andrew hicks | architect

Re: A BID FOR TWO NEW PROJECT BUILDINGS:

- A. A NEW CAFETERIA AND OFFICE ADDITION-LYNN CAMPUS PROJECT 1920-3809-002
- B. A NEW CAFETERIA/MULTI-PURPOSE ROOM BUILDING-STRAWBERRY CAMPUS PROJECT 1920-3809-001

ADDENDUM #2 March 15, 2021

M301_ADD1

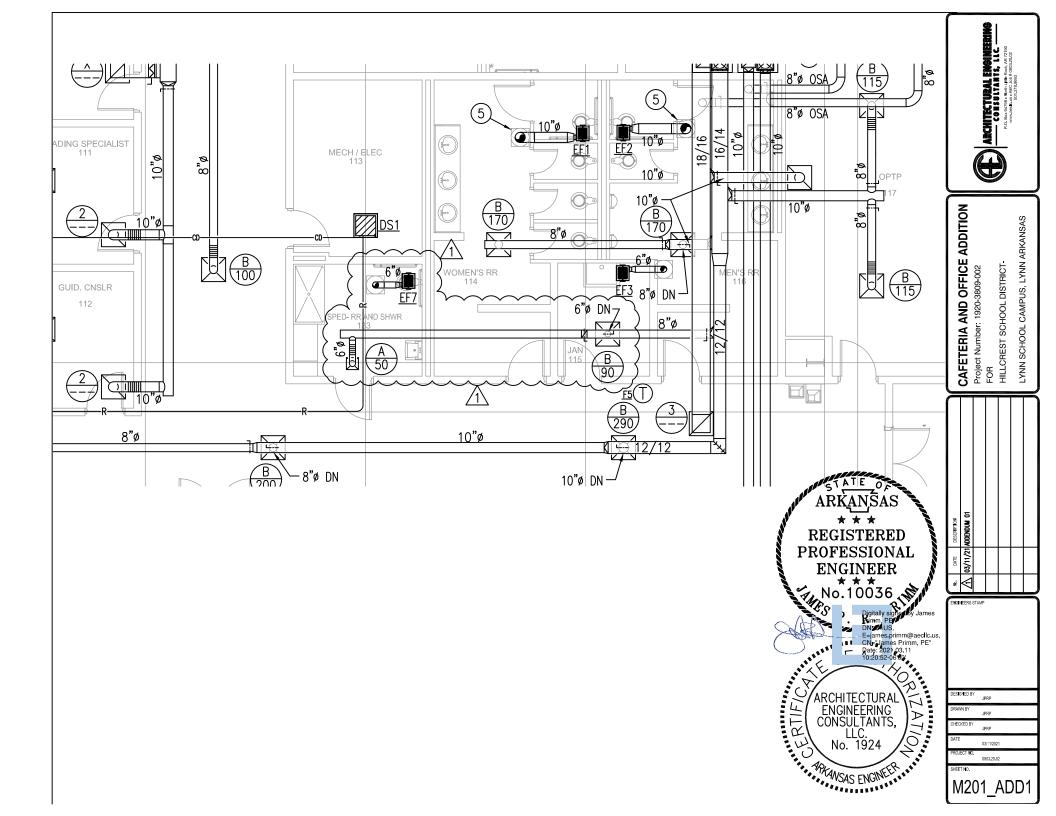
- 8. LYNN, AR PROJECT- A special education restroom and shower room #133 (SPED RR AND SHWR) was added to the project just before bidding and the mechanical and electrical plans have been now been revised and to reflect this change. The revised sheets are attached to this addendum. In addition to the attached electrical changes add one additional 120v circuit for an exhaust fan in this room.
